Service Bulletin

S.B. No: 157

Title: FIVE YEAR FUEL TANK INSPECTION

Issue 3: New paragraph 7 added. Following paragraphs re-numbered accordingly.
 Figures 1a and 1b added.

FIGURE 1a PRE MOD M500/M554

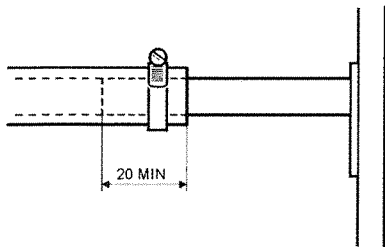
6. Ensure filters, vent lines and fuel lines are clean and unobstructed.
 7. Wing Tank Aircraft:
Ensure vent line hose clips are correctly positioned Ref Figures 1a and 1b. If vent line cannot meet dimensions at both ends, then replace vent line with new tube (SAL Stores Code 126-36-054).
